April 14, 2006

Subject: **Workplan for Monitoring Well Installation Addendum**  
Bernard's Gas  
1051 Airway Blvd  
Livermore, California  
Apex Project No. NWP01.001

Subject: Fuel Leak Case No. RO0002440, Bernard's Gas, 1051 Airway Blvd., Livermore, CA -  
Work Plan Approval

DRAWN BY: J. Curry DATE: 4/12/06	<b>PROPOSED MONITORING WELL LOCATION MAP</b>	<b>FIGURE 3</b>
	REVISIONS		
	Bernard's Gas 1051 Airway Boulevard Livermore, California

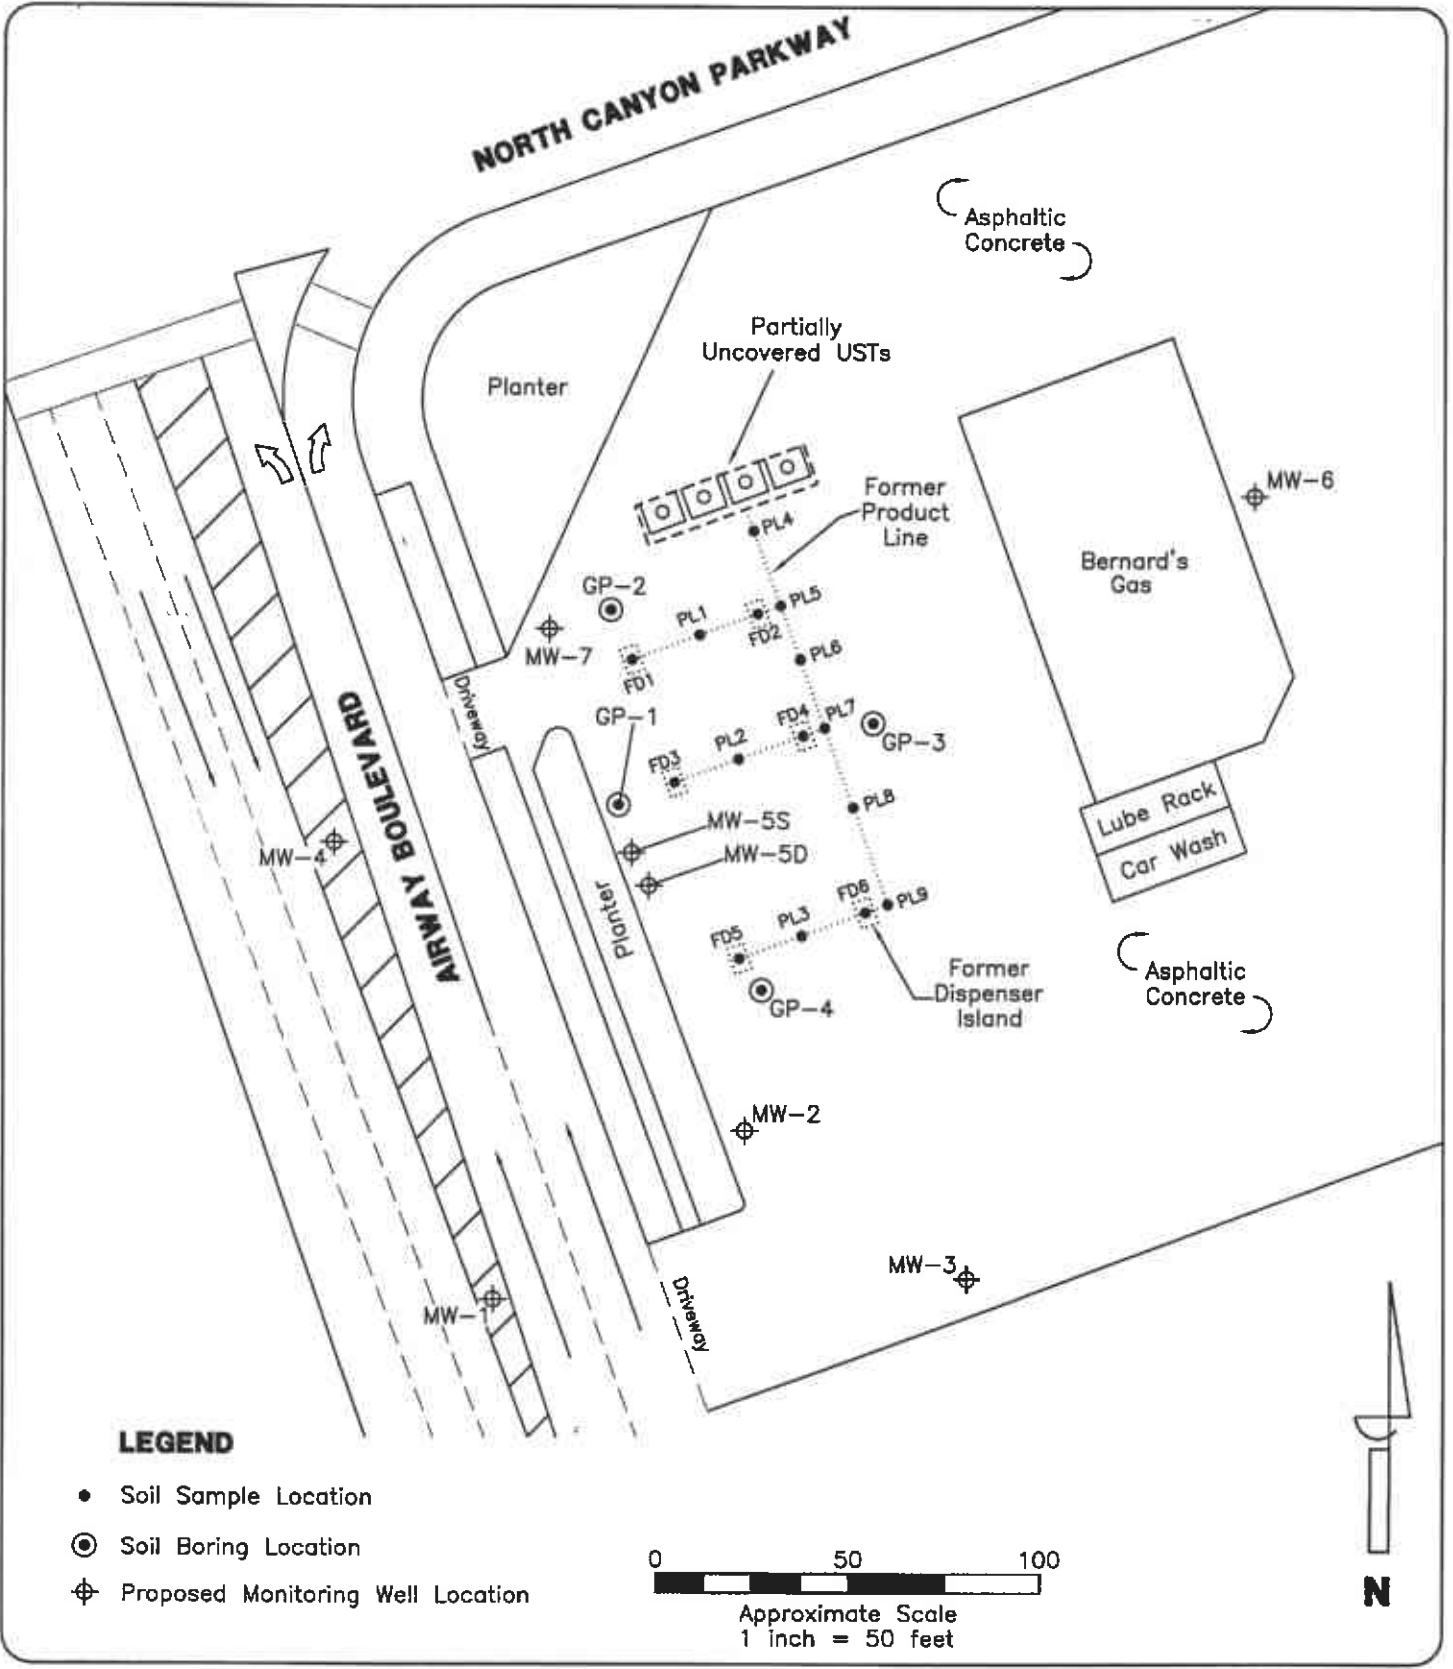
Apex proposes modifying the proposed shallow groundwater monitoring wells and one deep monitoring well to the locations as requested by the AECH and shown on Figure 3. The AECH requested one additional shallow well to be located next to the deep well. Depth to groundwater is approximately 27 feet-bgs. The proposed wells will be installed utilizing a hollow stem auger drill rig and completed as 2-inch diameter monitoring wells using Schedule 40 PVC and screened with 0.020-inch slotted screen. Shallow zone wells MW-1, MW-2, MW-3, MW-4, MW-5s, MW-6, and MW-7 will be completed to 35-feet bgs and screened from 20 to 35 feet bgs. The location of off site wells MW-1 and MW-4 is proposed in the center divide non-traffic area of Airway Boulevard as shown on Figure 3. Well MW-5d will be installed as a deep well to an unknown depth to be determined in the field, pending subsurface conditions. Well MW-5d will utilize a 5-foot screened interval and the bentonite seal will be placed between the first and second zone as to prevent cross contamination. Subsurface conditions will be determined by continuously coring the bore hole from 35-feet until a viable second aquifer zone is determined.

Attachment 1: Revised Figure 2 – Site Plan Map  
Attachment 2: Groundwater Program Wells, Figure 4-11, Zone 7 Water Agency

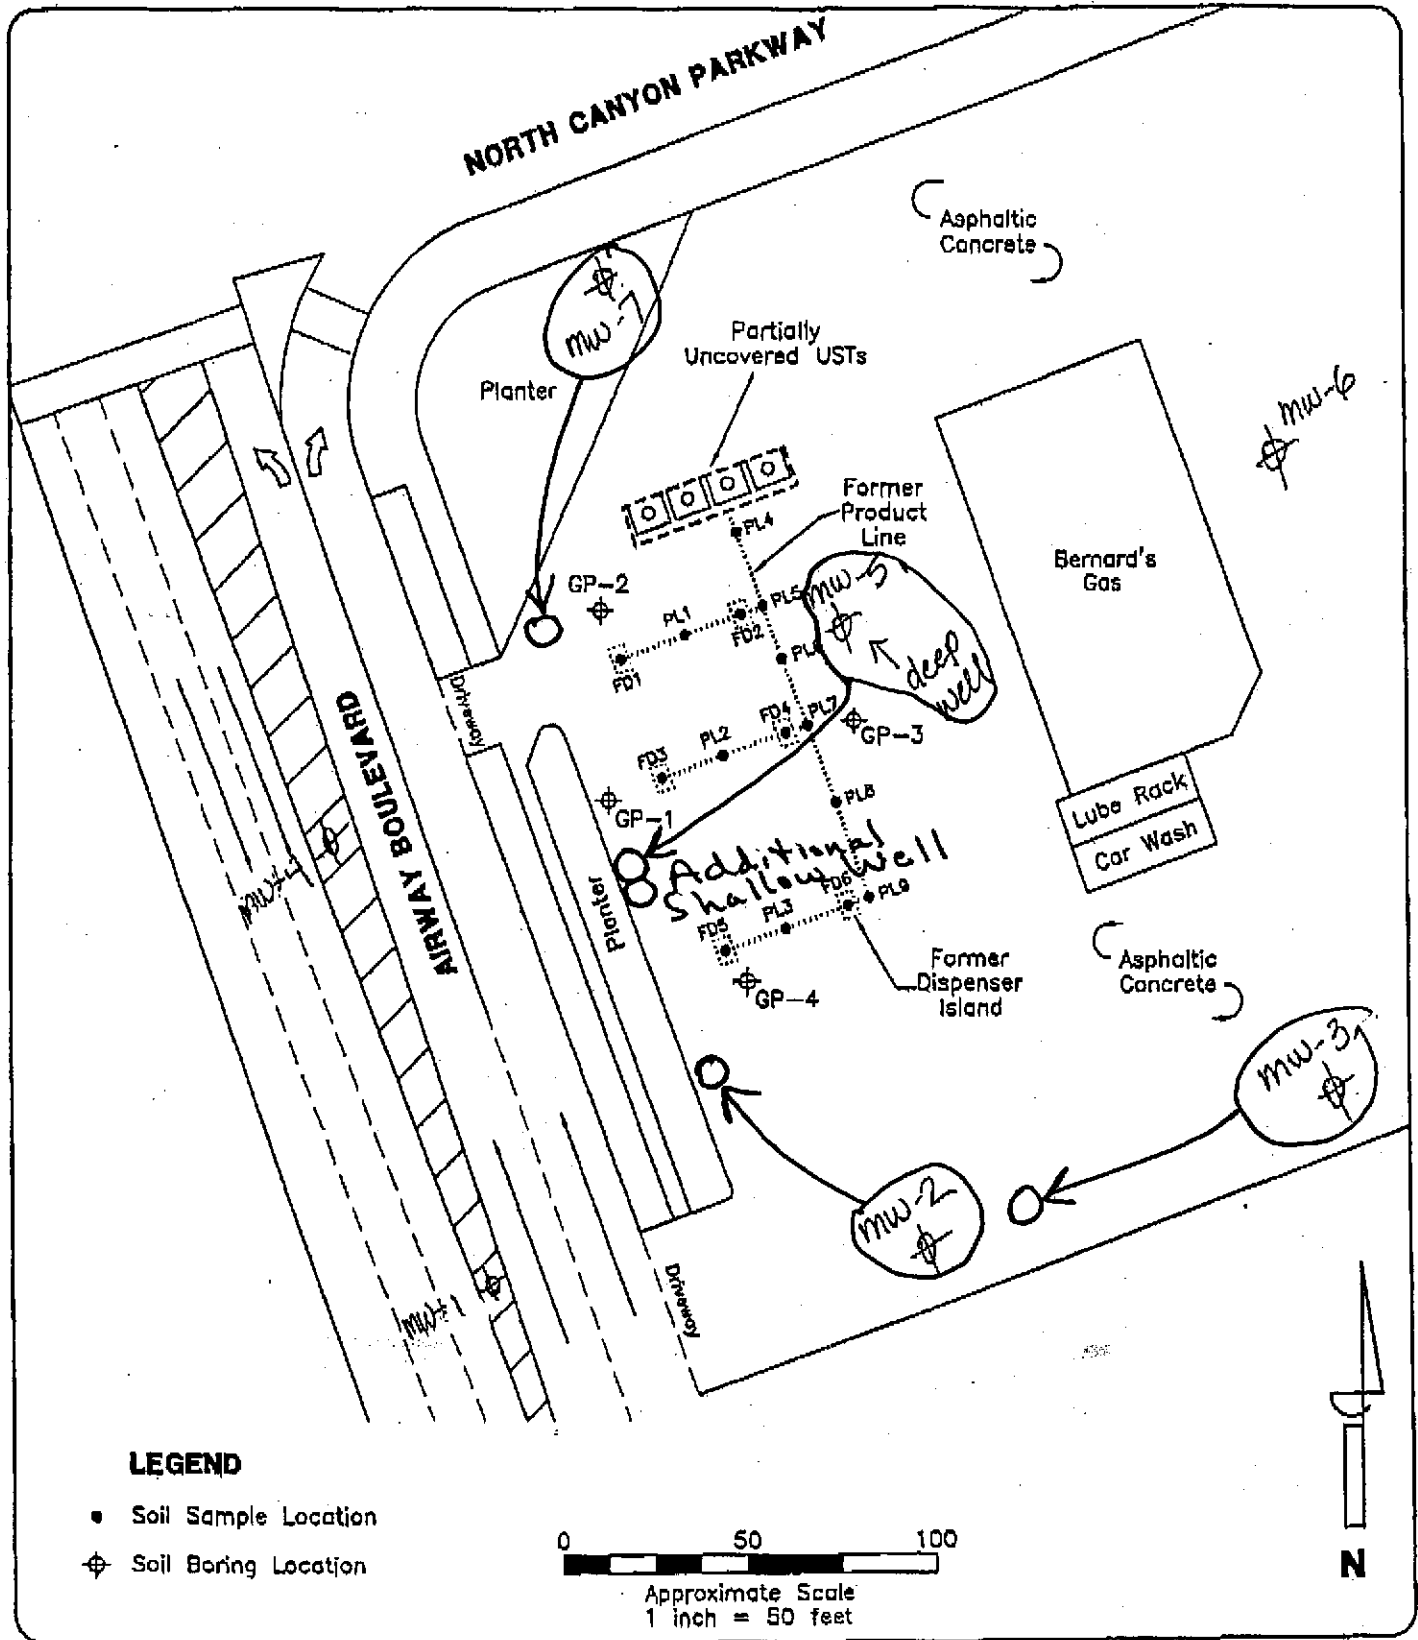
3. **Proposed Well Locations.** On the attached figure, please see the suggested revisions to the proposed monitoring well locations. ACEH also requests that an additional shallow monitoring well be installed adjacent to the proposed deep monitoring well, MW-5.
